**Optimization Evaluation  
North Penn Area 6 Superfund Site  
Lansdale, Montgomery County, Pennsylvania**

Report of the Optimization Evaluation  
Site Visit Conducted at the North Penn 6 Superfund Site  
September 22, 2011

April 27, 2012

**Figure 4. Rogers Mechanical (former Tate Andale)**

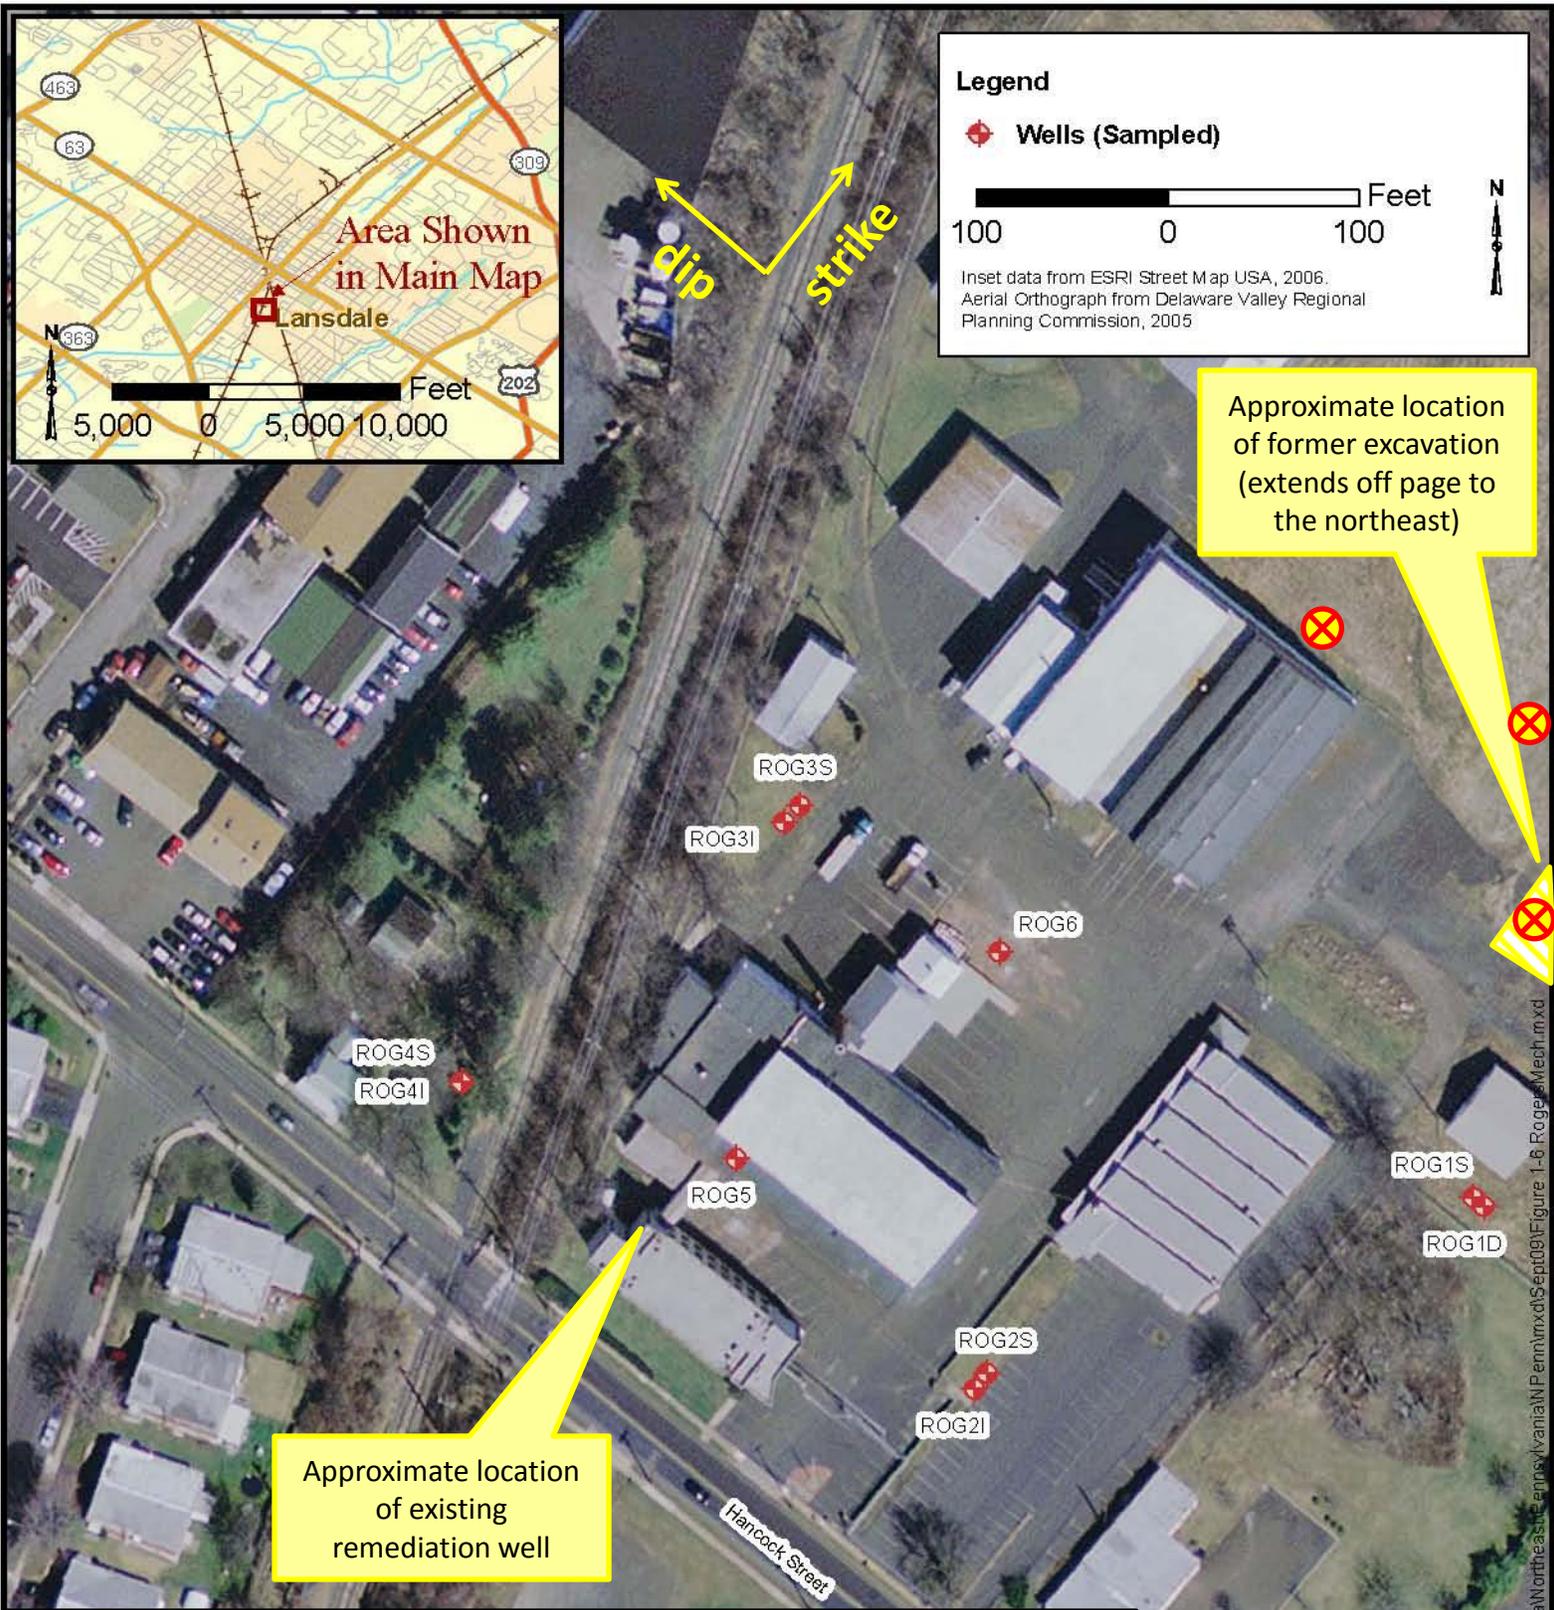
contamination, and to understand the approximate extent of contamination. Figure 4 presents a current aerial view of the property, the location of the existing groundwater remedy, the approximate area of the former excavation, and potential locations for new monitoring wells. The first round of wells should be installed to a depth of approximately 70 ft bgs to focus on areal coverage rather than depth. With these relatively shallow wells, the whole well can be sampled with standard purge techniques with discharge of purge water to the ground surface rather than low-flow sampling or PDB sampling at specified intervals. The wells should be surveyed and gauged for water levels with the other wells to improve the understanding of groundwater flow in the area. After one round of sampling, the site team can evaluate the potential need for further characterization, including deeper monitoring wells. If contamination that merits remediation is identified in groundwater, then the unsaturated bedrock overlying the contaminated groundwater should also be investigated for potential remediation with SVE pilot testing.

**Figure 5. Royal Cleaners**

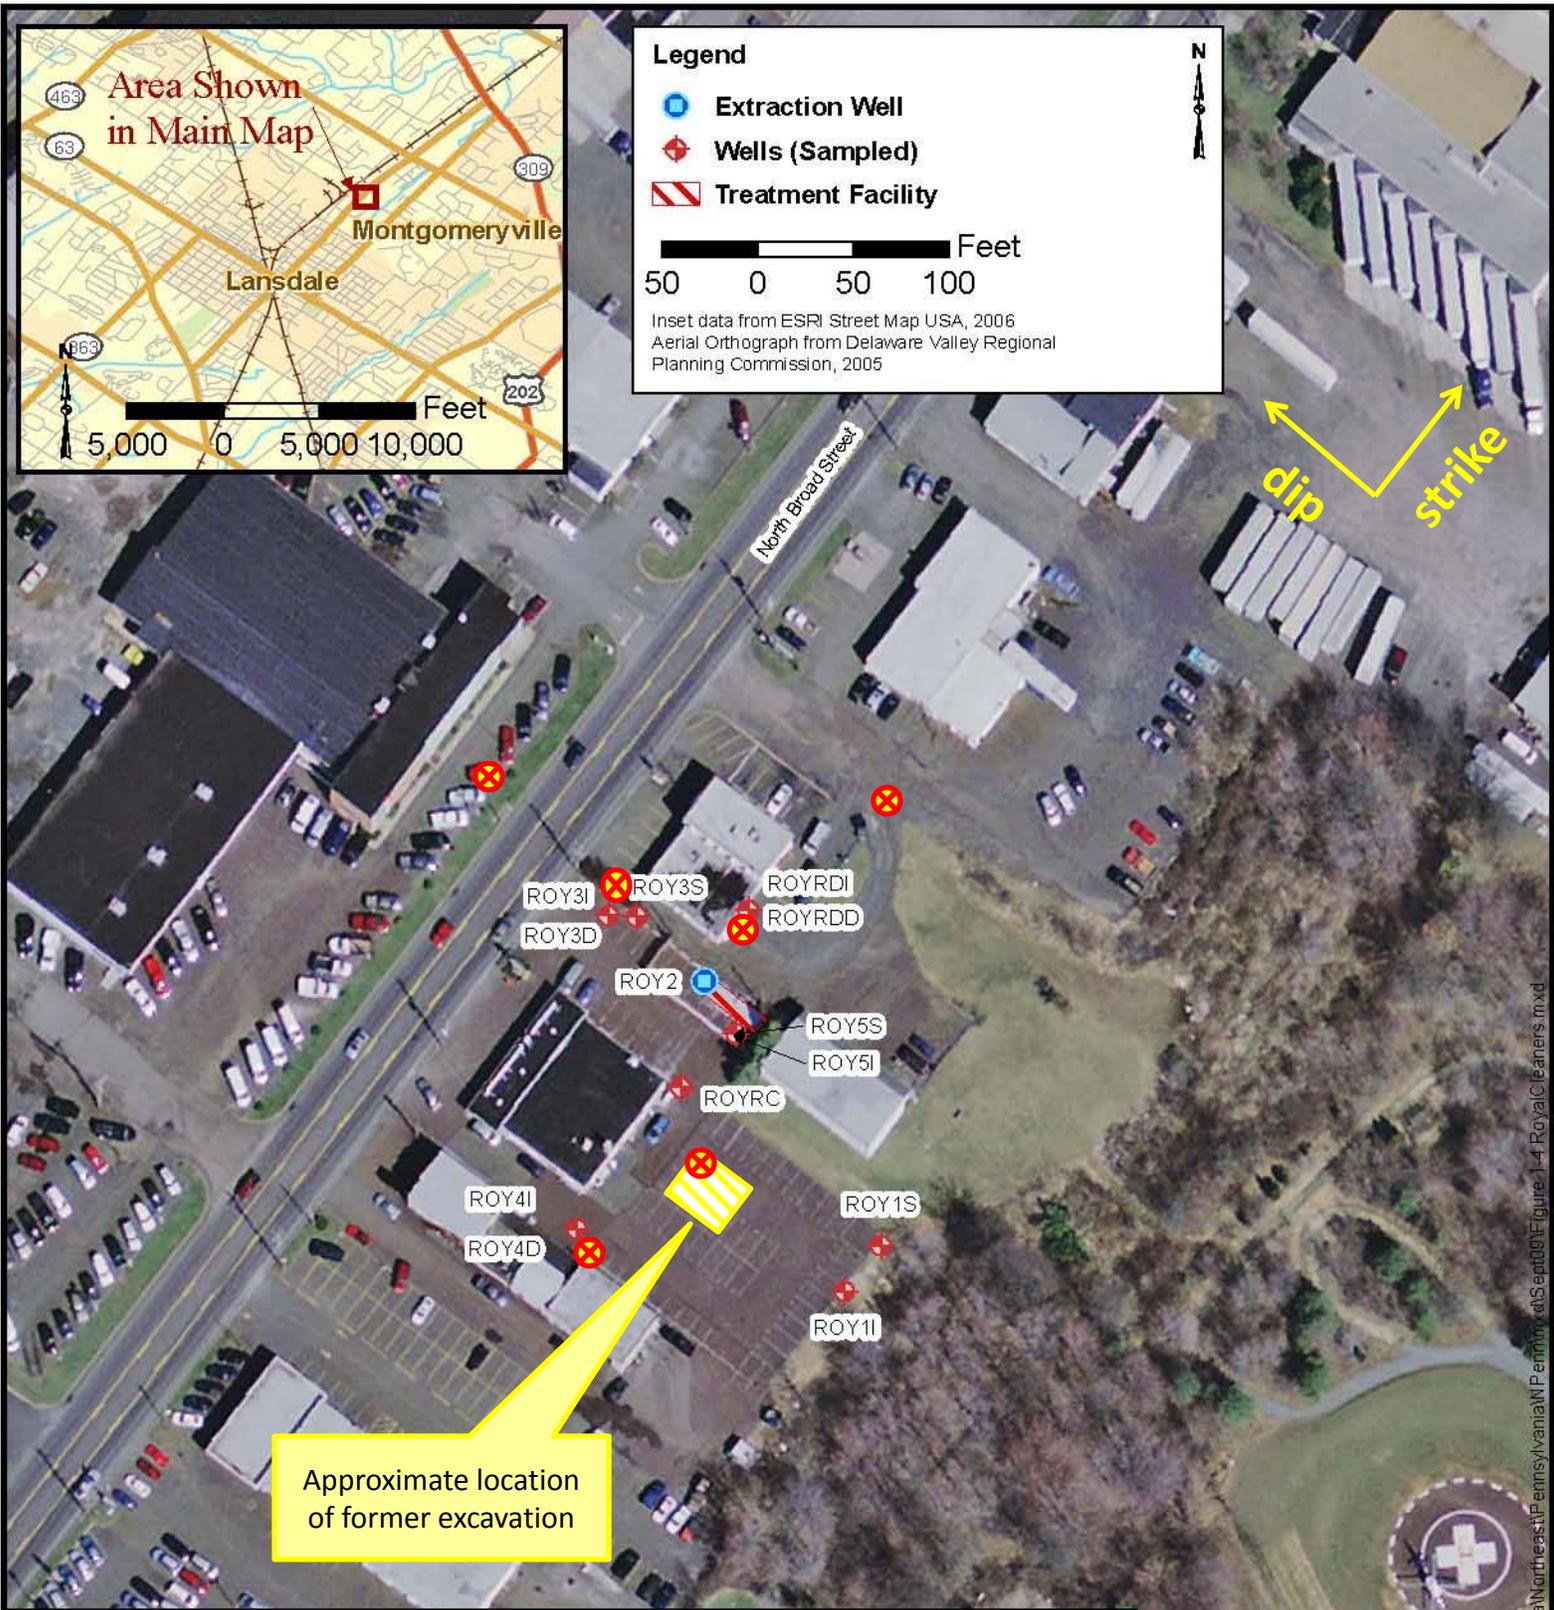
Shallow contaminated soil and buried drums were removed as part of a Removal Action in 1991 (see Figure 5). The depth of the excavation was not reported. Subsequent soil sampling during the 1994 RI identified remaining soil contamination in the shallow overburden (less than 10 ft bgs), but all detections were determined to be sufficiently low that additional remediation was not needed. The highest detected PCE concentration during the 1994 RI soil sampling was 42 µg/kg.

Substantial contaminant mass likely remains in the unsaturated zone; from the bottom of the excavation (assume 10 ft bgs) to the water table (approximately 50 ft bgs). This unsaturated zone contamination is not directly addressed by the groundwater remedy and may continue to provide an ongoing source of contamination to groundwater. The optimization review team recommends investigation of the unsaturated bedrock in the same manner as described for Electra Products. The optimization review team envisions the following scope of work:

- Work planning.
- Installation of six shallow SVE wells screened from 5 to 20 ft bgs (three between the former excavation and ROY5S and three between ROY5S and ROY3S) to preferentially extraction vapors from the weathered bedrock and upper competent bedrock.
- Installation of six deeper borings open from 20 ft bgs to the water table at 50 ft bgs (three between the former excavation and ROY5S and three between ROY5S and ROY3S) to address vapors in fractures of more competent bedrock, if any.
